RE: Submission of Annual Geotechnical Inspection – 2025, Mary River Project – Nunavut, August 29, 2025; Project # CA0055338.6747

2025 Geotechnical Inspection Recommendations and Implementation Plan

2025 Geotechnical Inspection Report

Annual Geotechnical Inspection – 2025

Figure 4: Mary River Mine Site Layout Map – South-Eastern Zone – KM106 run-of-mine ore storage facility and MS-07 sedimentation pond - © 2023 Digital Globe, Inc.

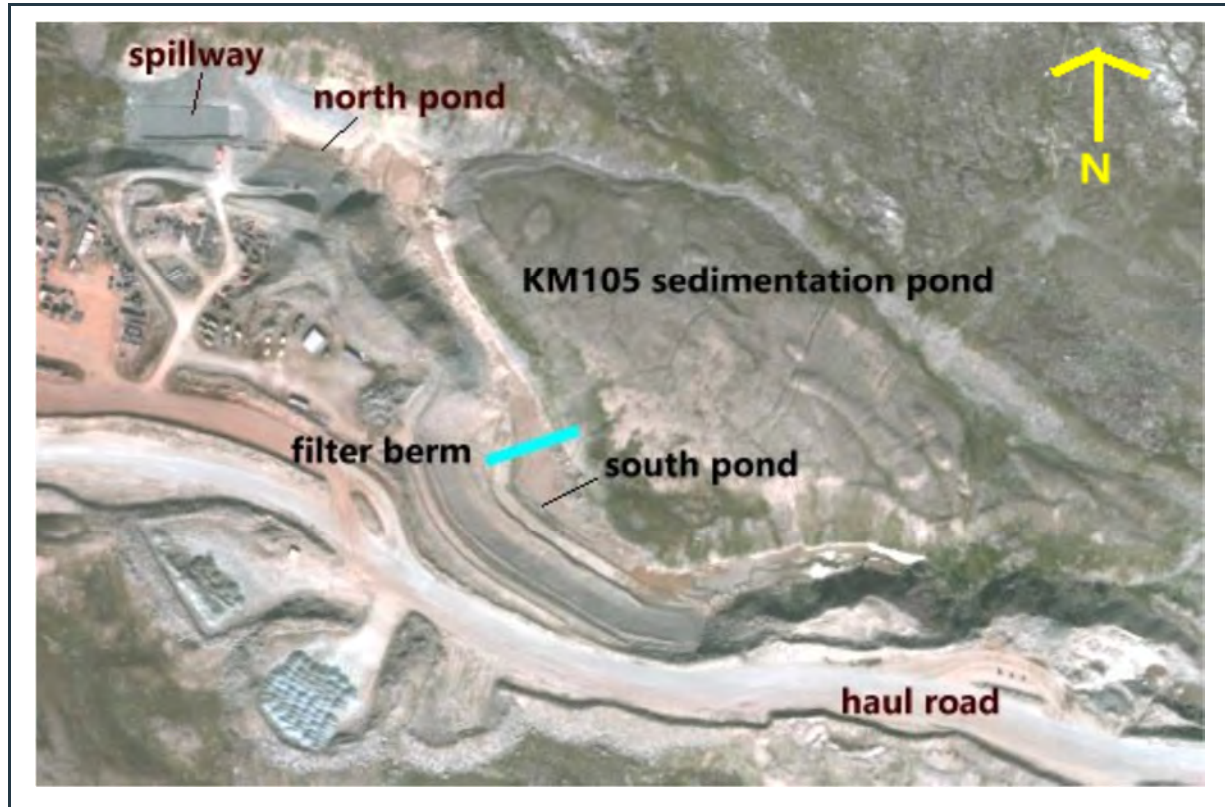
Recommendation: One side of a culvert is partially blocked and should be cleaned to facilitate uninterrupted flow of water through the pipe. A second culvert is damaged and clogged. This culvert should be replaced or restored. Alternatively, this culvert could be removed permanently and the slopes of the ditch reinstated.

The MS-06 surface water management pond collects surface water from the area of the crusher pad. The surface water is collected in side-ditches around the crusher pad and conveyed into the MS-06 pond. One of the culverts (culvert A, marked in Figure 2) is located under the adjacent road at the crusher pad entrance and connecting one of the side ditches with the north corner of the MS-06 surface water management pond. The discharge end of the culvert appears to be well maintained (Figure 24); however, the intake end of the pipe is partially clogged, as shown in Figure 25. That end of the culvert should be cleaned as soon as practically possible to facilitate uninterrupted flow of water through the pipe. The liner within the pond and on the upstream slopes of the stable perimeter berm appears to be intact, shown in Figure 26.

A second culvert (culvert B, marked in Figure 2) is located near the south-east corner of the pond, within another drainage ditch. As shown by the yellow circle in Figure 27, this culvert is damaged and clogged, preventing the collected water from the upstream section of the ditch reaching the MS-06 pond. As recommended in earlier reports as well, this culvert should be replaced or restored to pass water effectively. Alternatively, this culvert could be removed permanently and the slopes of the ditch reinstated.

Baffinland Action: Baffinland can confirm that the culverts pass water currently and the second culvert is not clogged. The culverts are scheduled for routine cleaning and steaming in spring 2026 to remove the build up of sediment and ice within the culverts to ensure water conveyance to MS-06.

Figure 58: View of the slightly damaged liner (yellow circle) at the intake channel to the MP-05 pond.

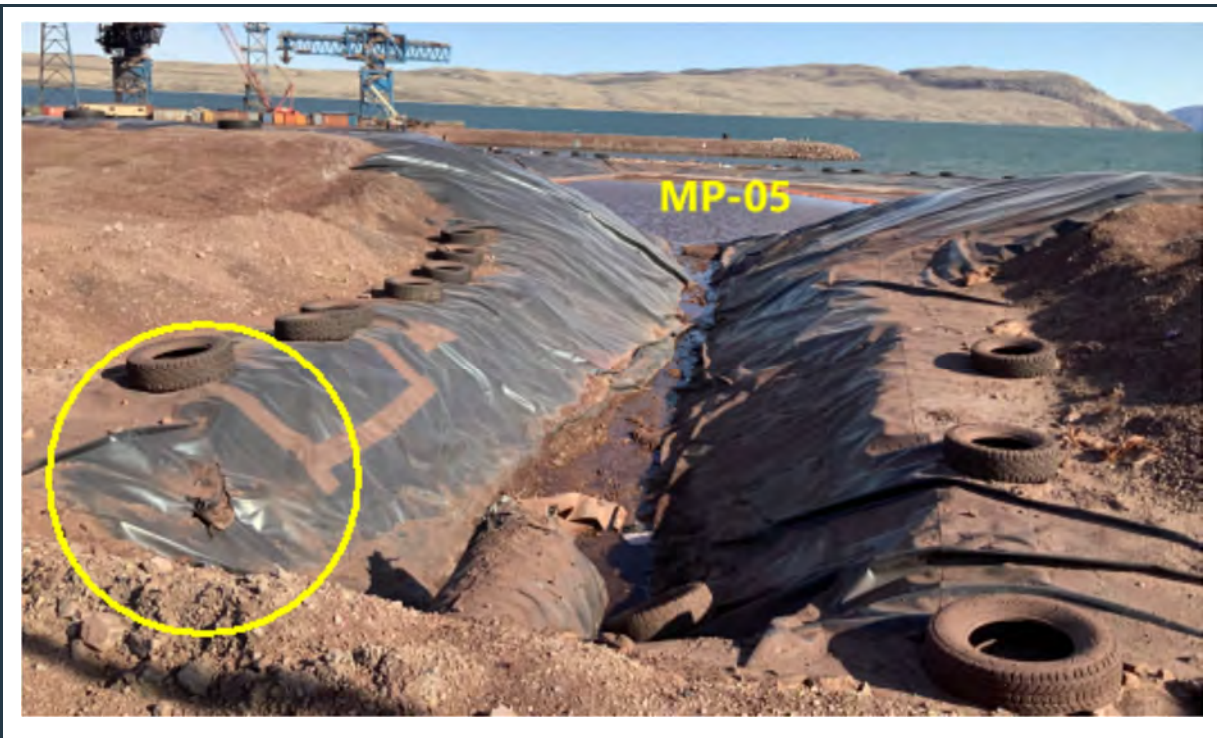
Recommendation: Minor damage was noted in the liner at the intake channel to the MP-05 pond, as shown in Figure 58. The damage should be repaired as soon as practically possible.

The MP-05 surface water management pond is located adjacent to the north-east corner of the ore stockpile, while the MP-06 and MP-06A ponds were constructed at the north-west corner. The three ponds are in excellent condition with stable, well-maintained berms and intact geomembrane liners, as shown in Figures 57 to 60. Only minor damage was noted in the liner at the intake channel to the MP-05 pond, as shown in Figure 58. The damage should be repaired as soon as practically possible.

Baffinland Action: Baffinland notes that that the damage in no way currently impairs the conveyance of water to the pond and the impacted liner is well above the high-water mark of flow from the ditches. Baffinland will continue to monitor the liner damage and make repairs should it functionally impact the water conveyance
